Seattle Goodwill Industries Job Training & Education Center

MUP Design Review September 27, 2011 DPD Project #3012125

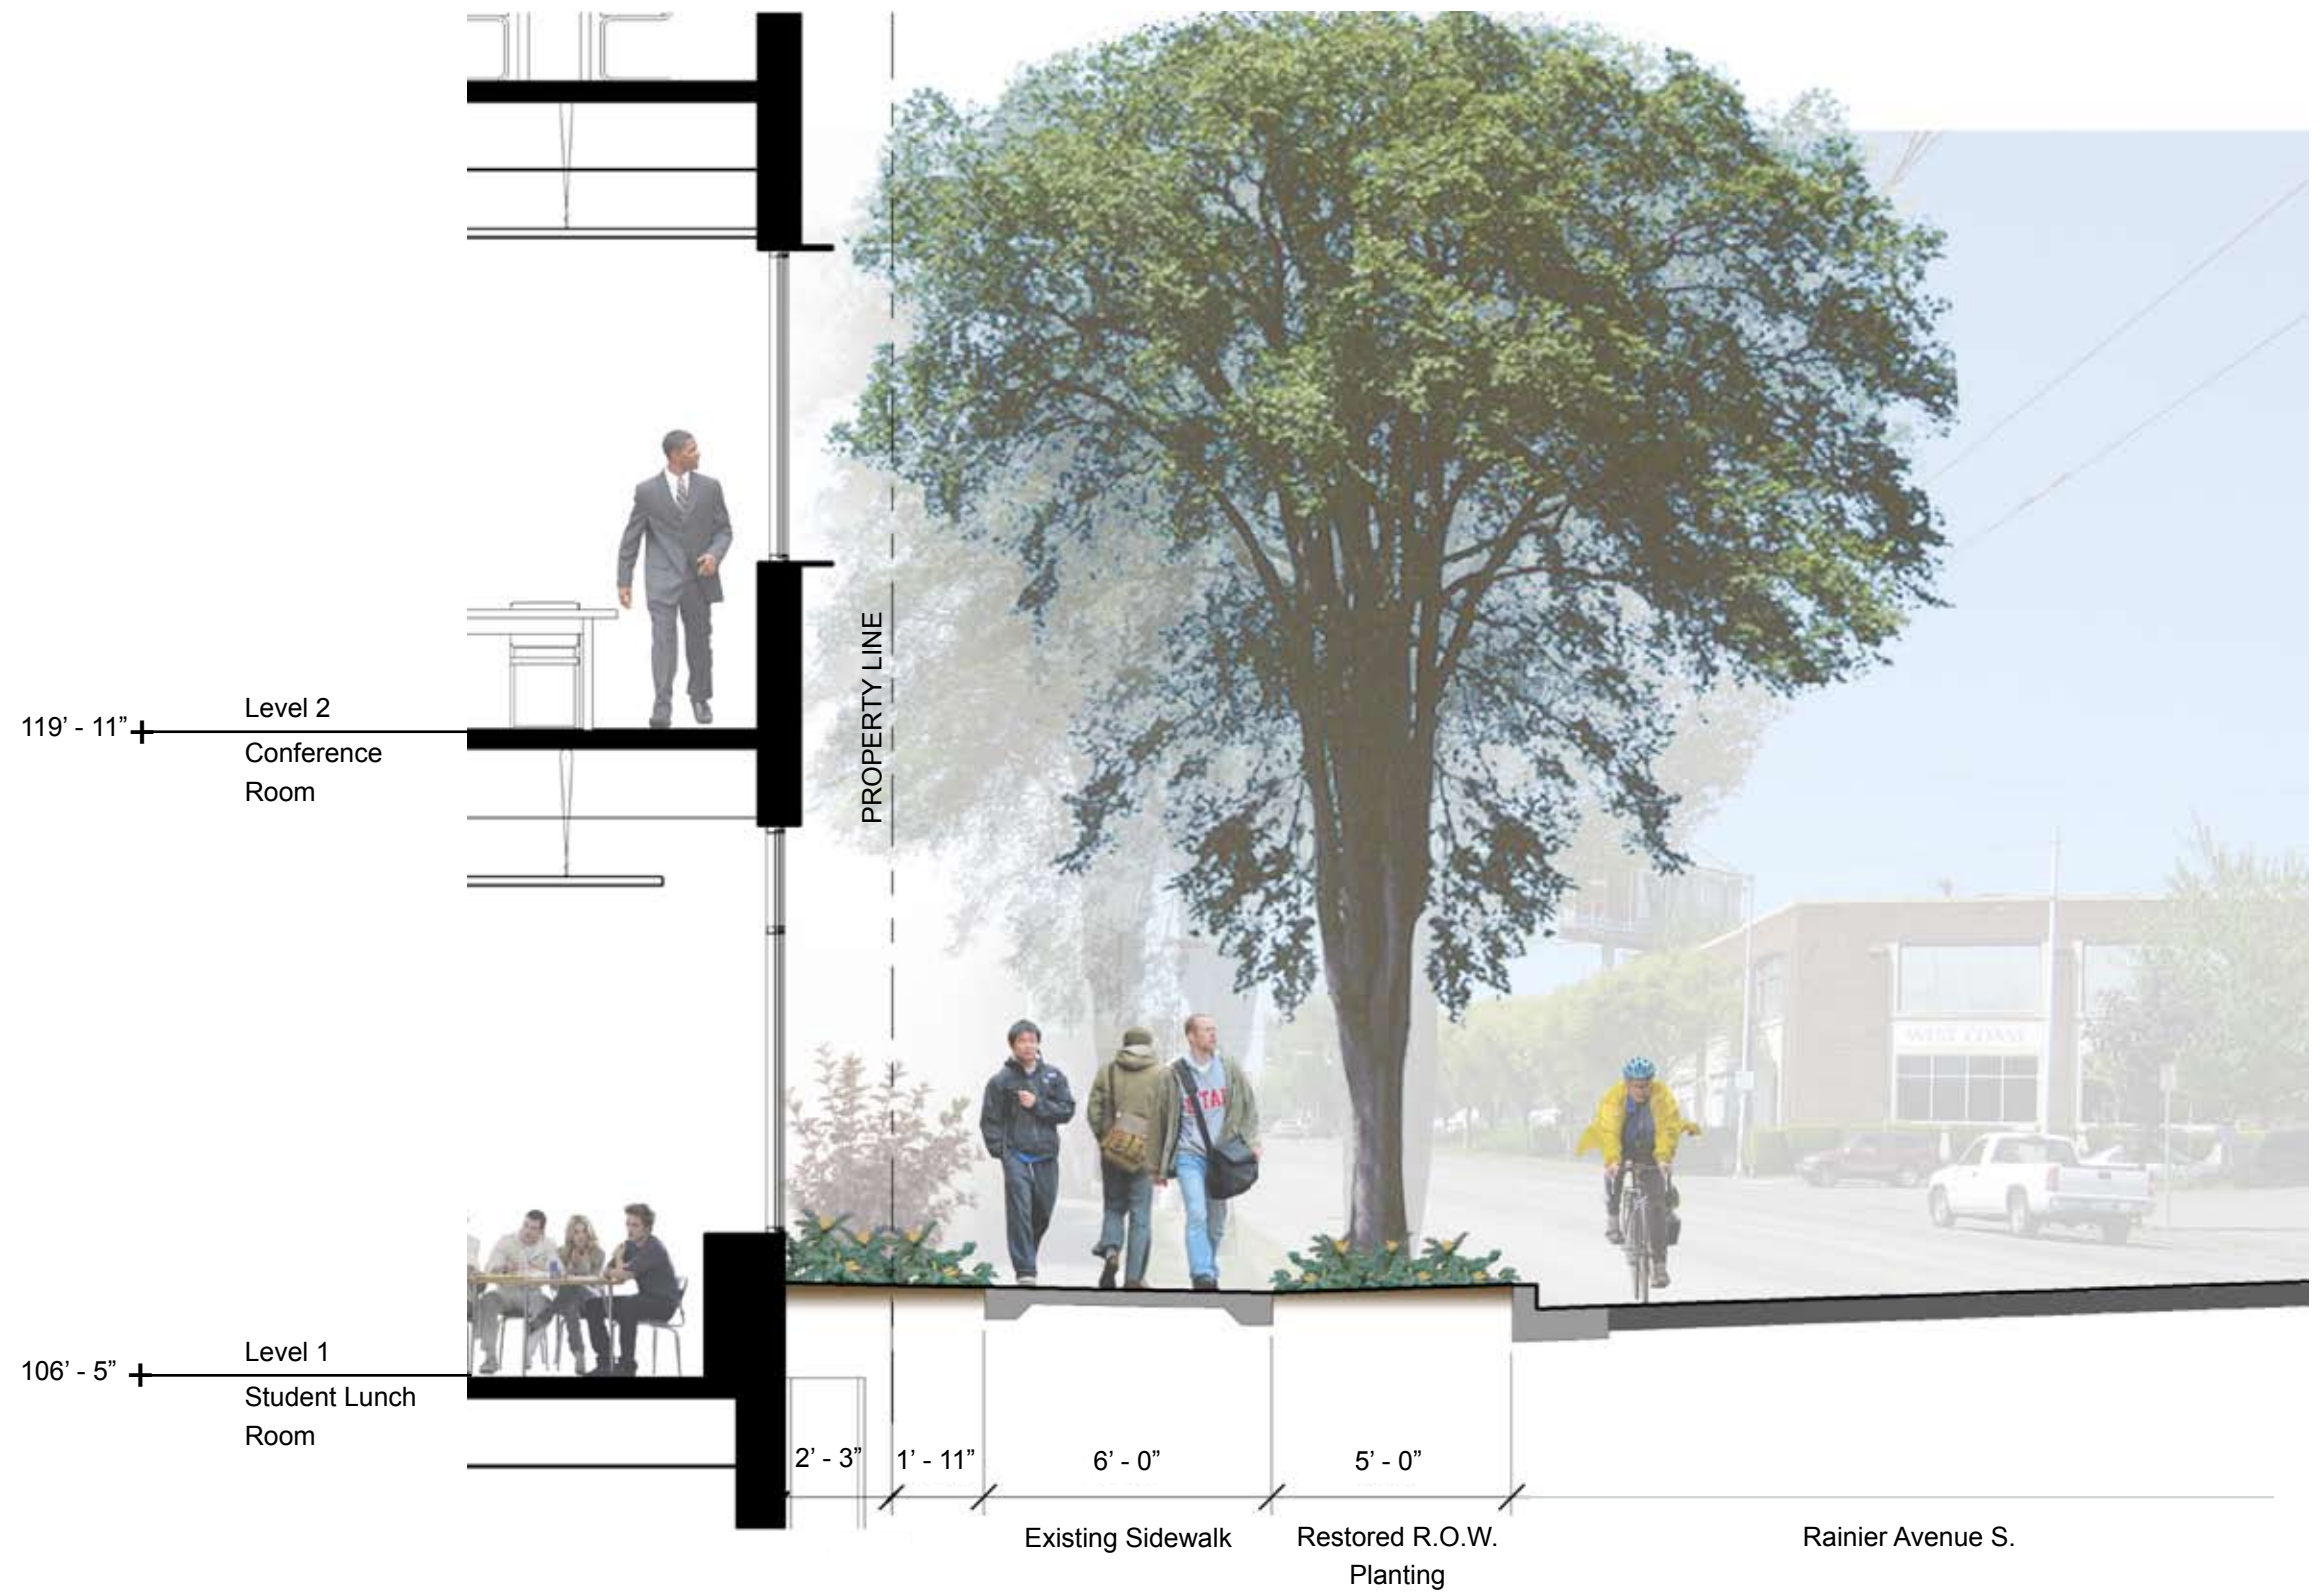
E-2 Landscaping to Enhance the Building and/or Site	#18 - At the Early Design Guidance Meeting, the Board stated that the landscape proposed should be shown and it should be demonstrated how the landscape will relate to future development of the Goodwill properties. In general, the landscape is very important to the proposal and needs to be well developed at the recommendation meeting.	See Site Plan. The landscape plan for the entire Goodwill campus is not part of this phase of the development. However, the proposed design for this project does not preclude any future plans. By holding the building back from S. Dearborn Street, this project keeps views from Rainier Avenue and S. Dearborn open to the rest of the campus and any future developments. The addition of trees, planting areas, rain gardens and site seating along the east façade of the building improves the pedestrian experience along Dearborn Place S., which will be an important visual and physical connection to future development.

ENTRY - big blue lily turf, heavenly bamboo-Moon Bay, Isanti dogwood, blue-green moor grass, existing Bartram oak

NORTH SIDE - kinnikinnick, longleaf mahonia, beaked filbert, tall oregon grape, indian plum, red flowering currant, bald hip rose, cascara

RAINIER STREET SCAPE - Frontier elm, creeping mahonia, wintergreen, strawberry, sweet box, longleaf mahonia, existing tree

RAINGARDEN - palm sedge, dwarf red-twig dogwood, grooved rush, dwarf goat's beard, taper-tipped, lady fern, beach strawberry
